# Tampa Electric Company (TECO)
# Coal Yard Assessment
## Stantec Job No. 198800347

September 2010
Revision 2

Stantec has been retained by Tampa Electric Company to provide a review of the coal field equipment at the Big Bend facility. The review scope boundaries are from the dock through conveyors L1 and L2 that bring the coal to the tripper deck in the power house.

PICTURE CONV-D1-W

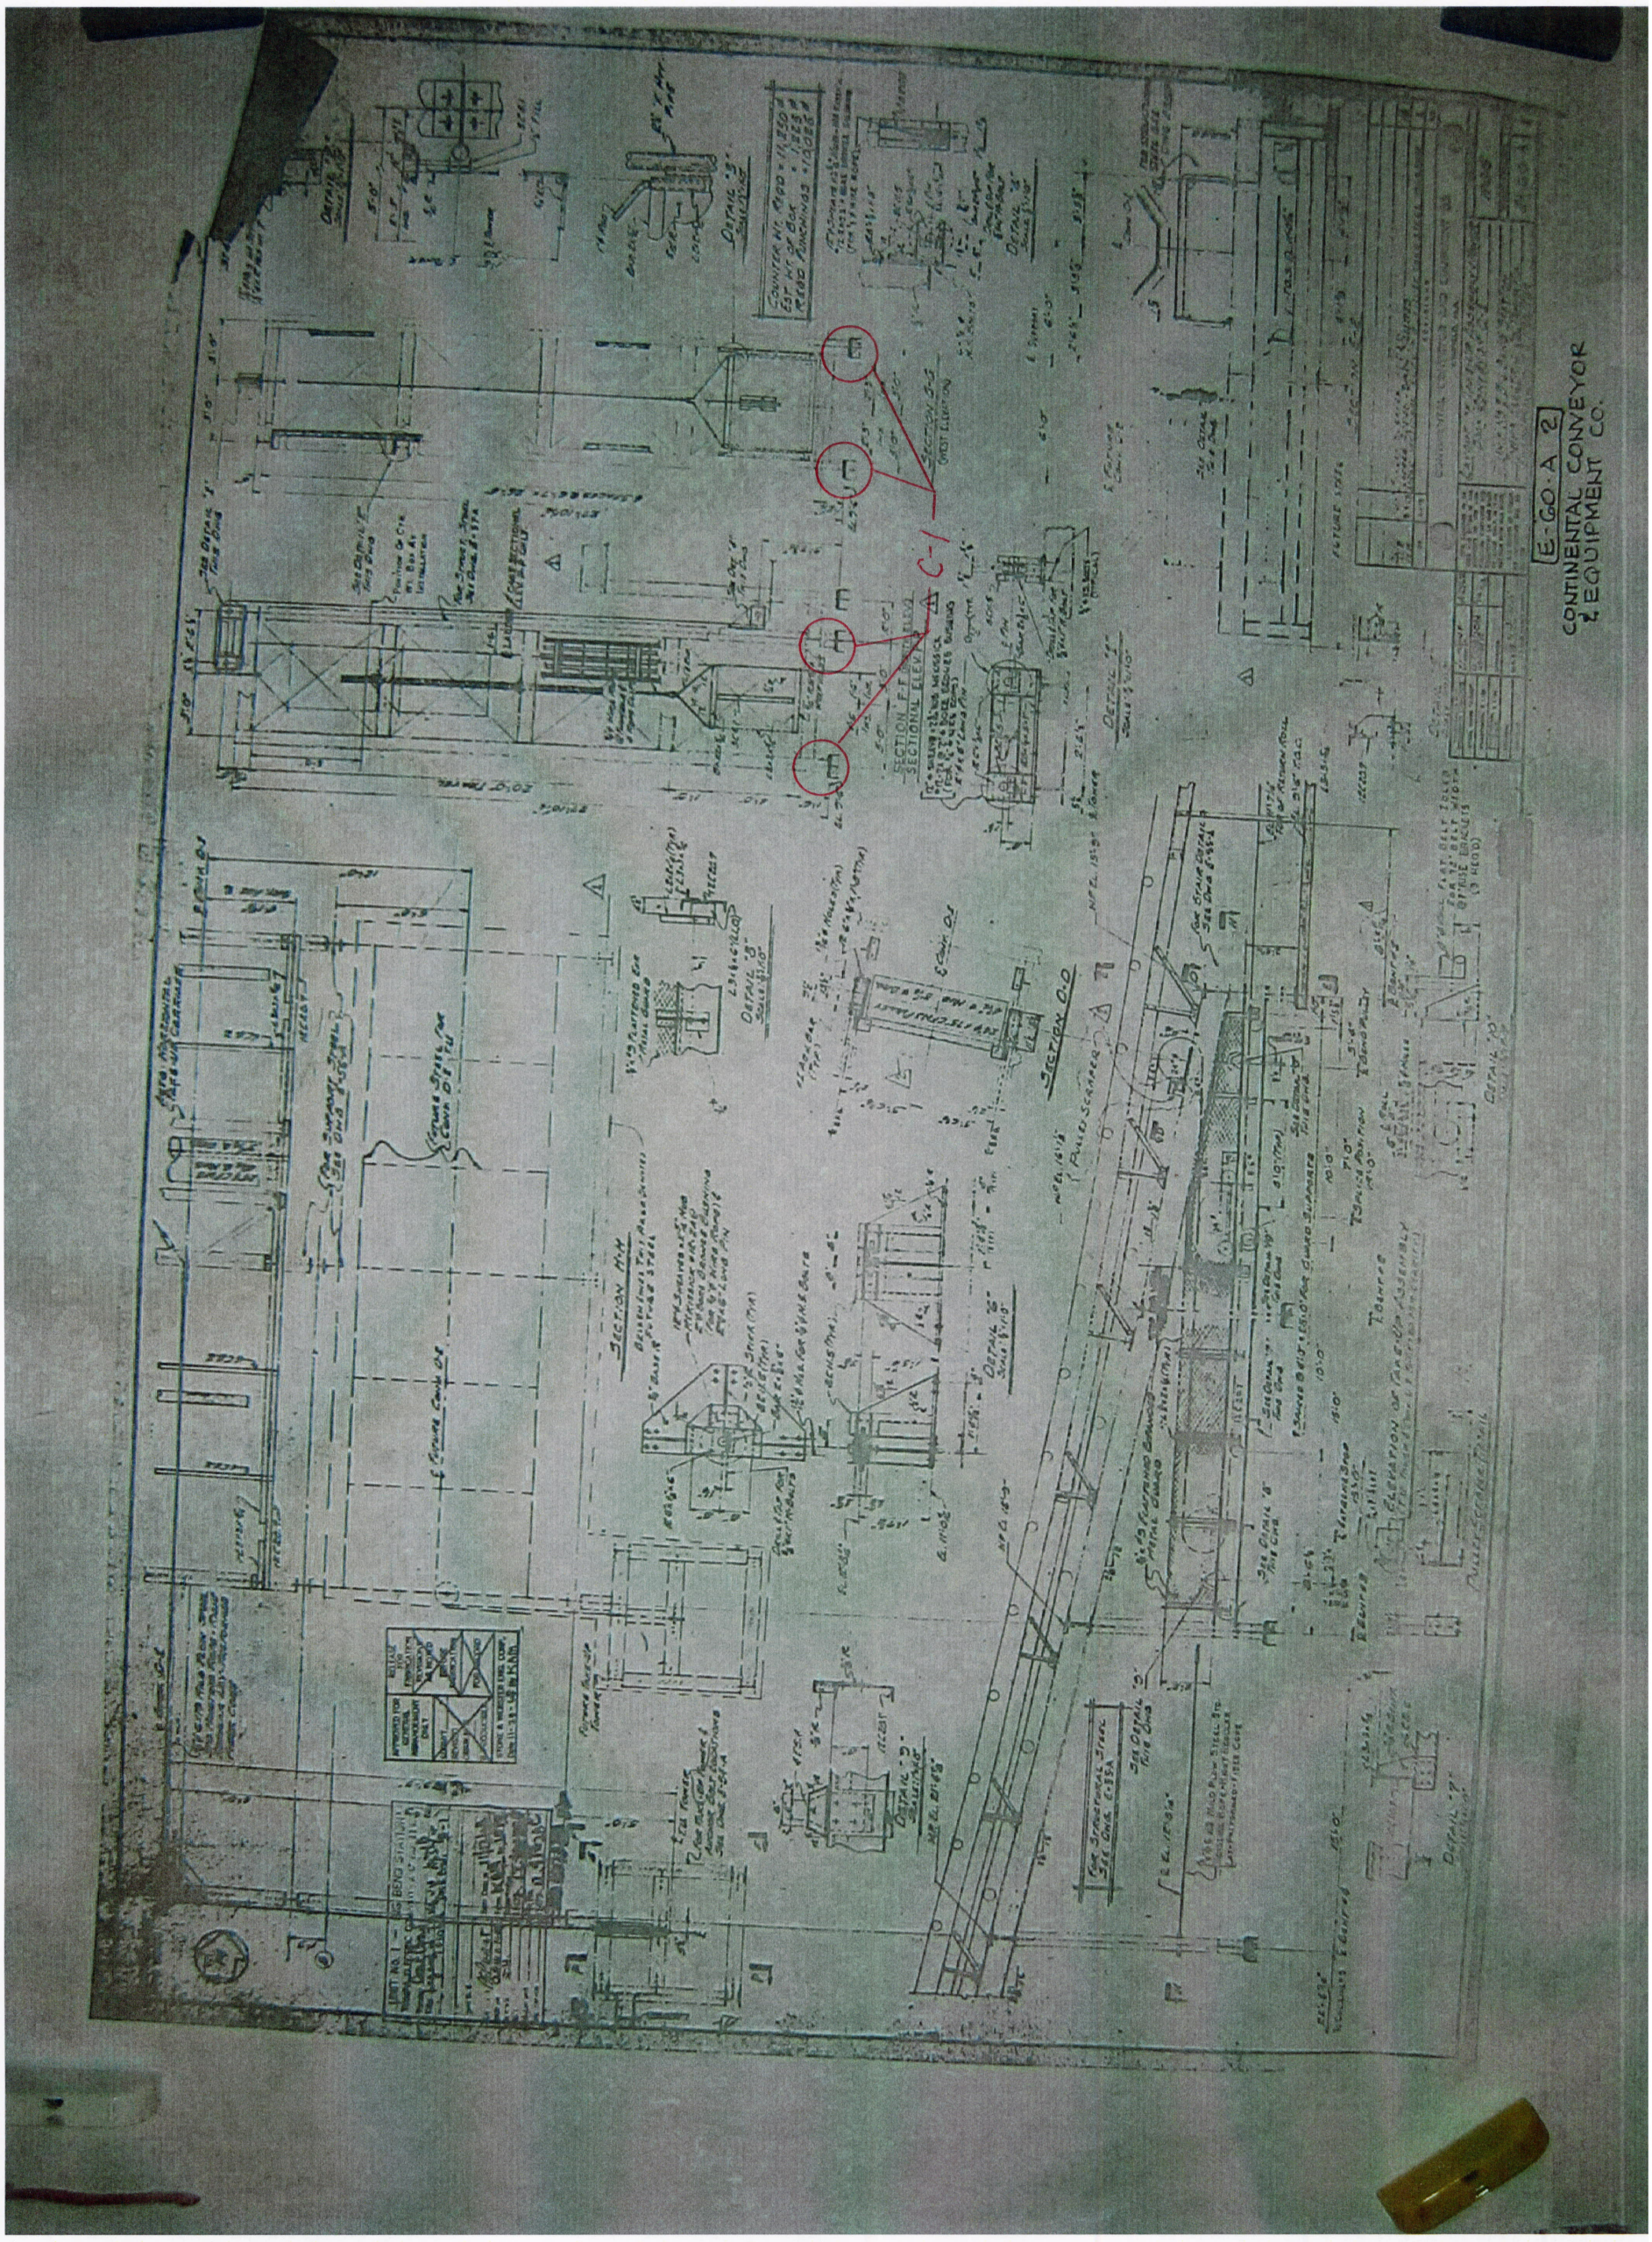
Loss of section of members (Pictures CONV-D1-W and CONV-D1-X).

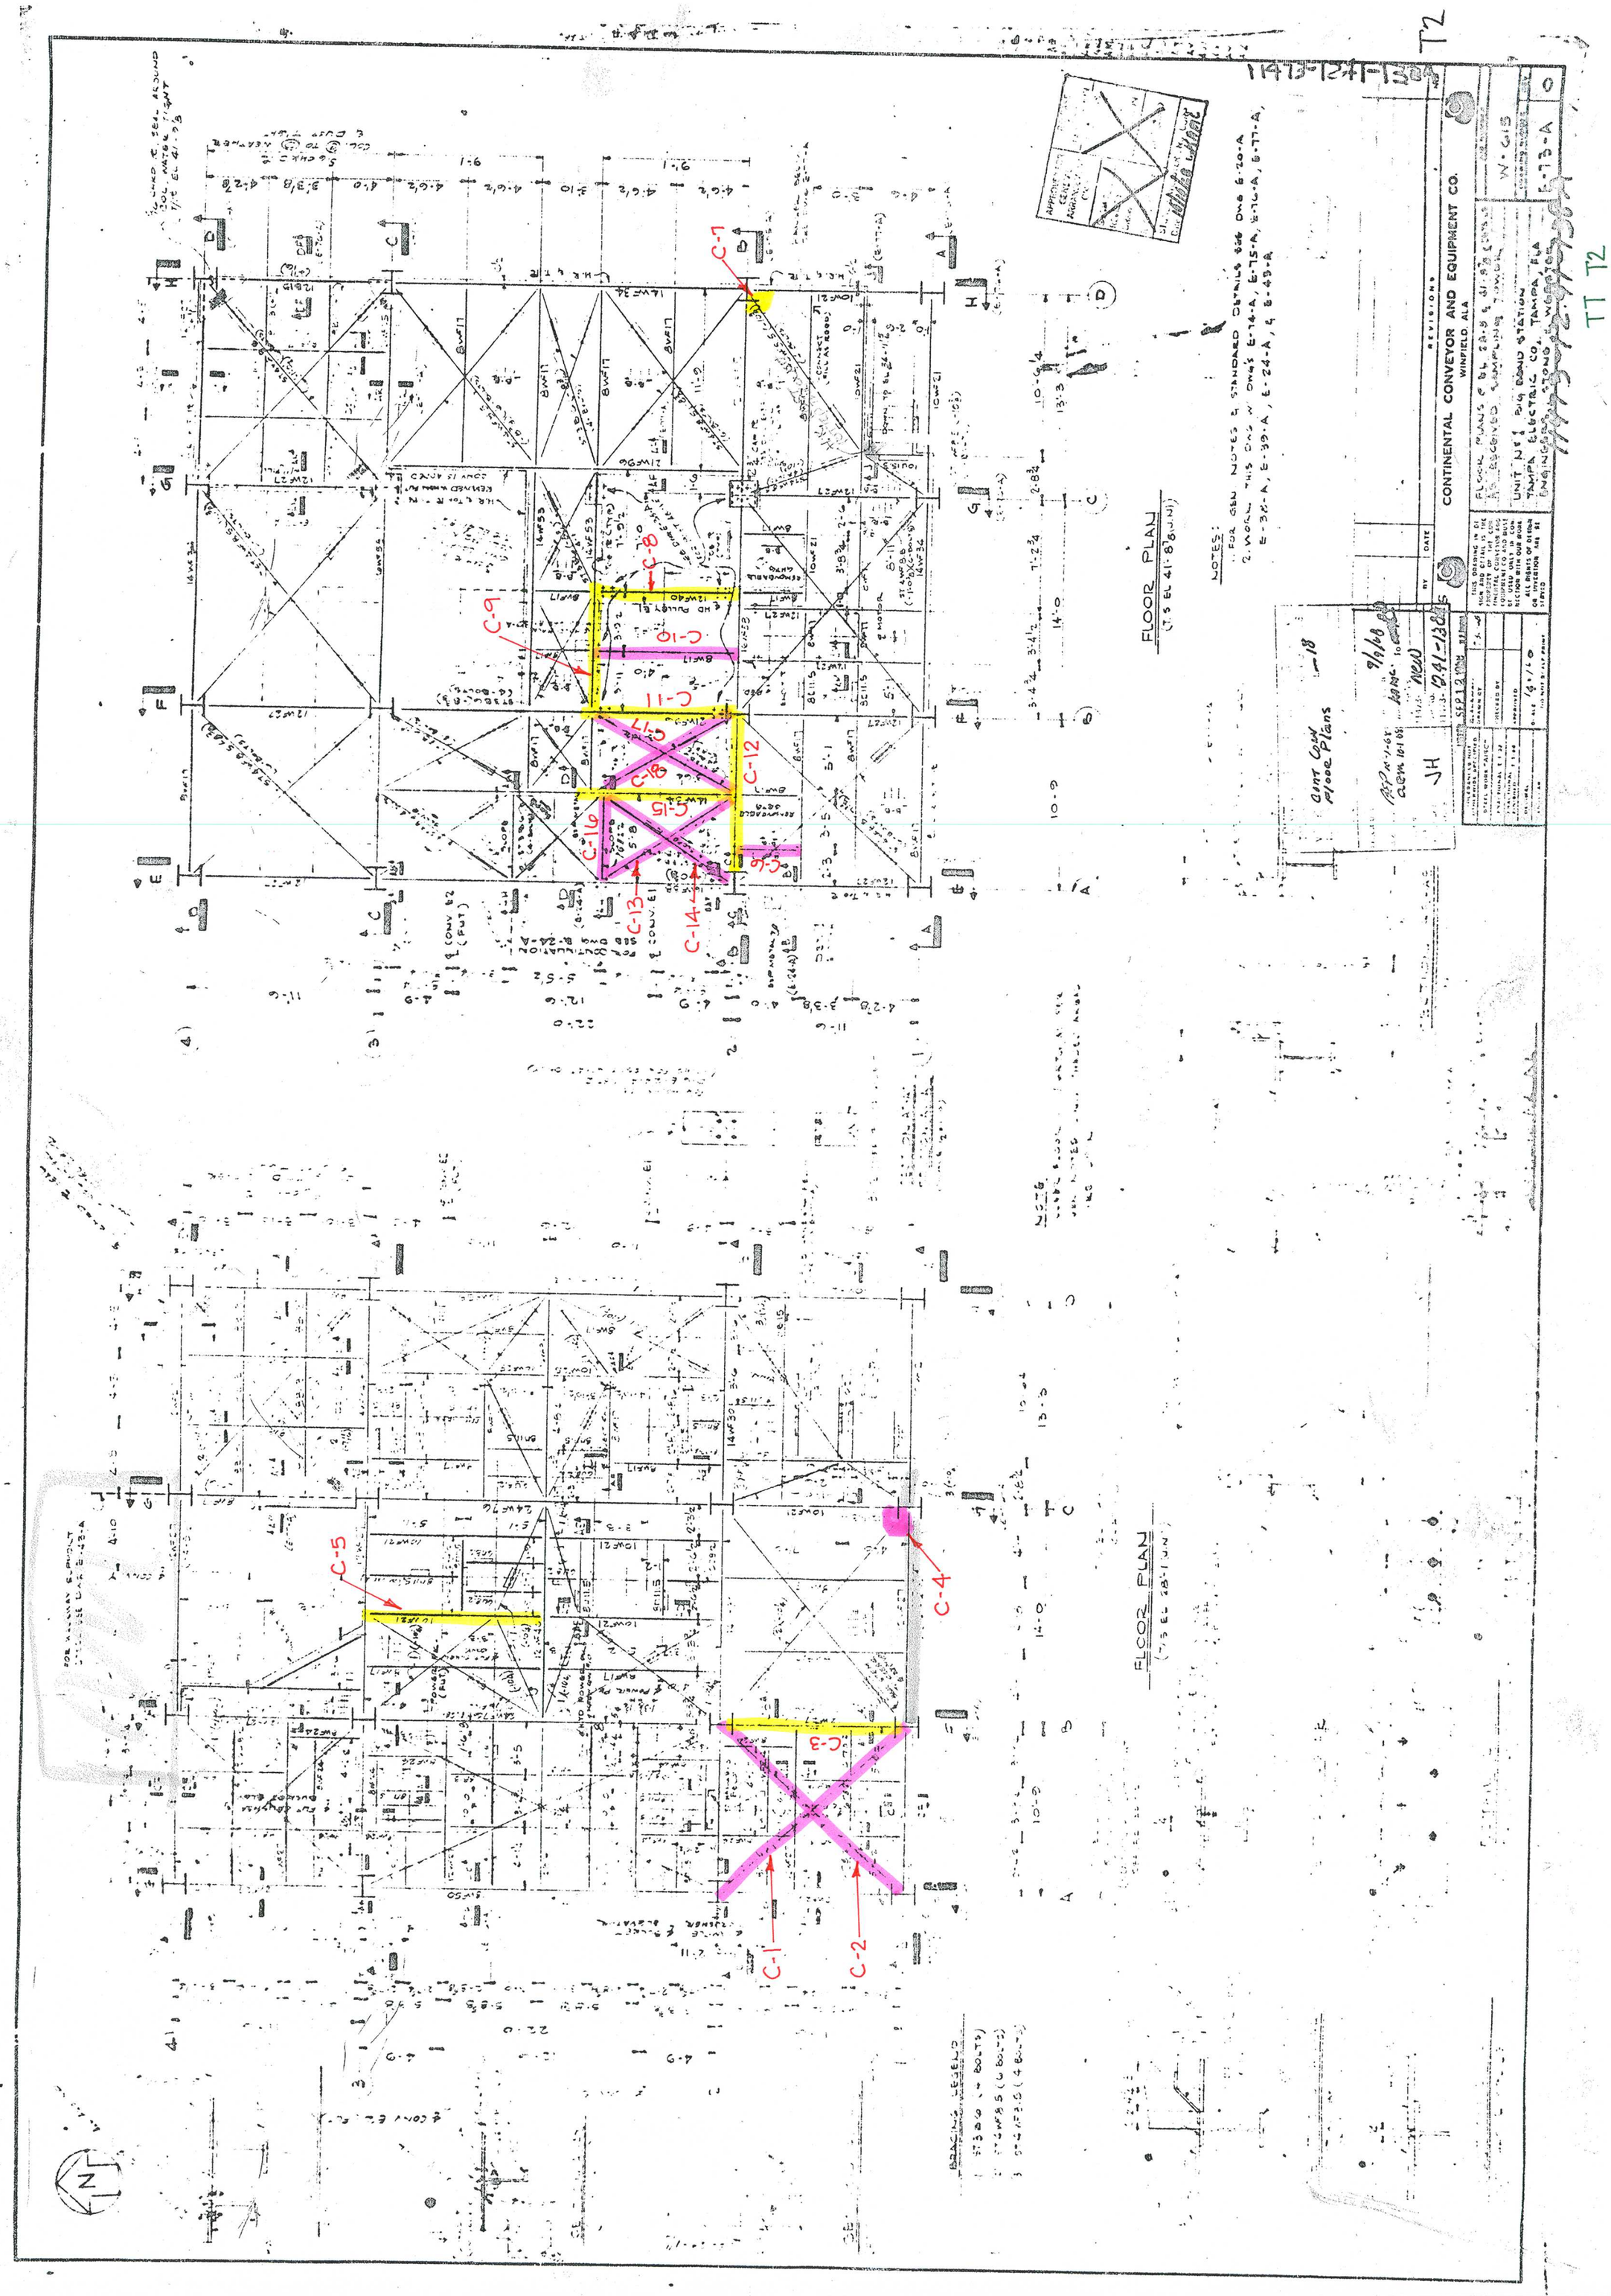
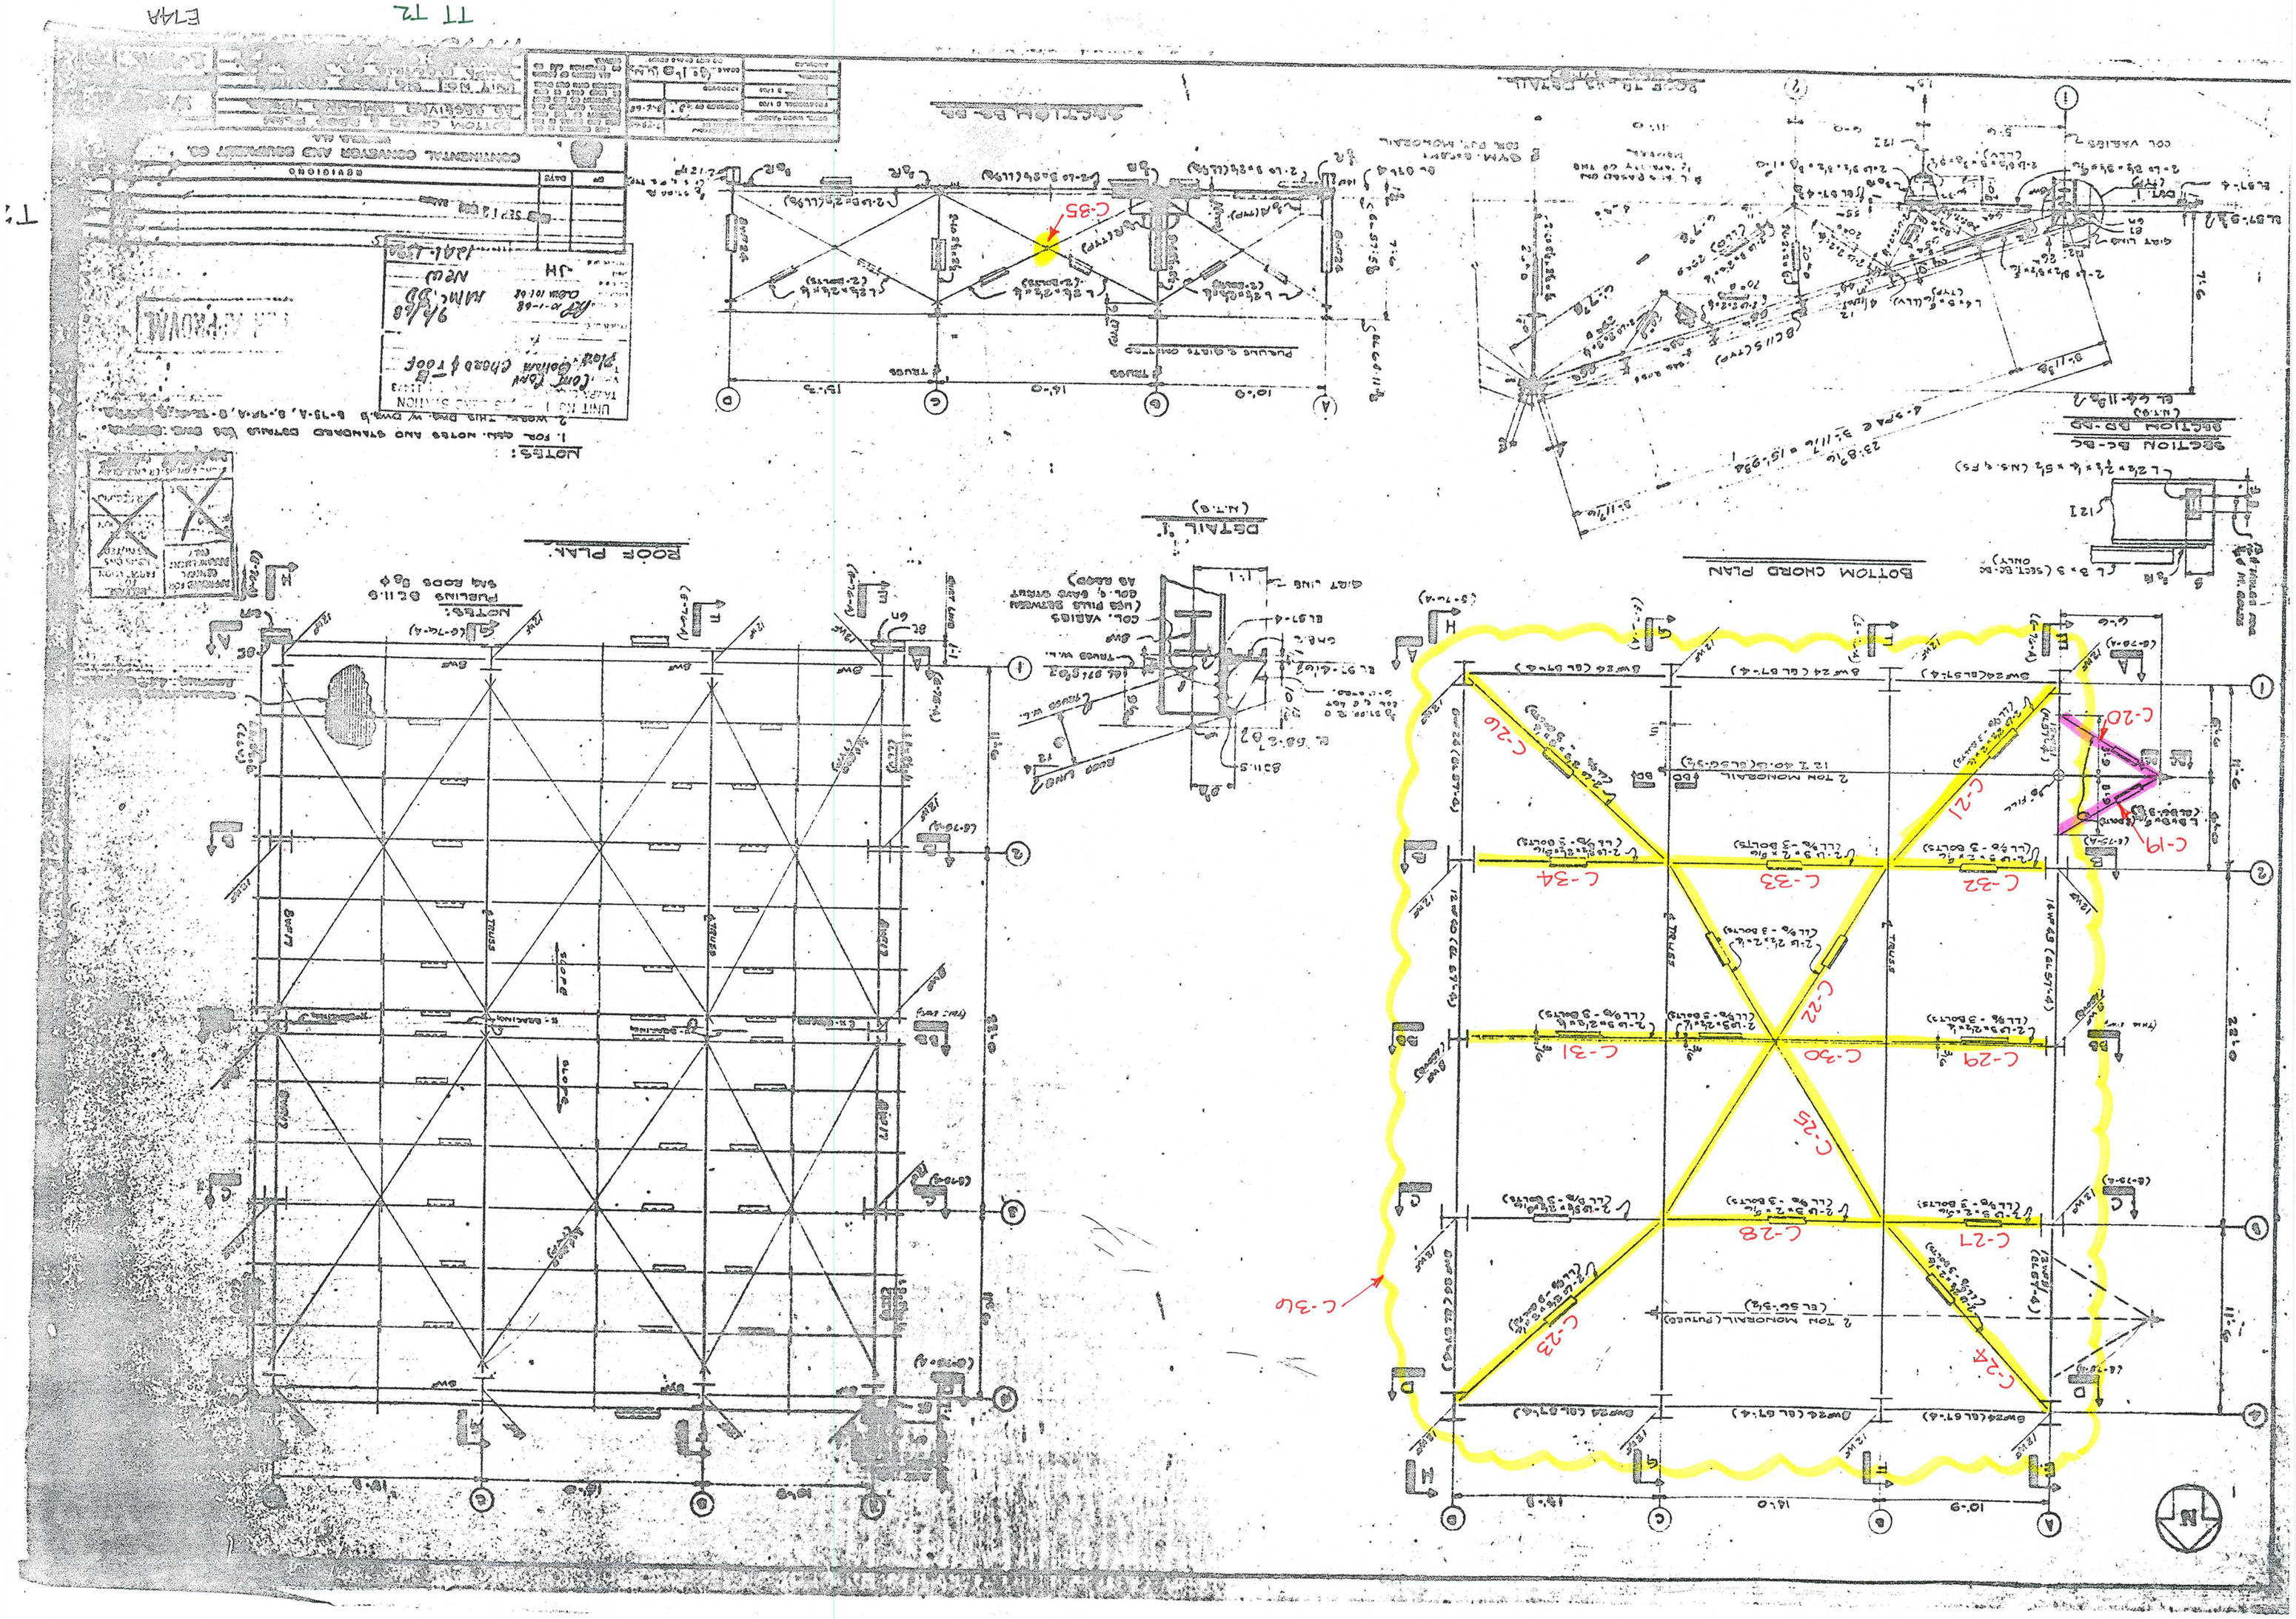
C-42 Connection of vertical brace to gusset plate has broken free and brace is no longer taking load. Recommend replacing gusset plant and field welding existing braces to new gusset plate. See included photo TTWR-T2-L.

| C-51 | Vertical bracing has moderate corrosion between the angles. Recommend cleaning and painting to prevent further damage. |
| C-52 & 53 | Vertical bracing has moderate corrosion between the angles and at gusset plate. Recommend cleaning and painting to prevent further damage. |
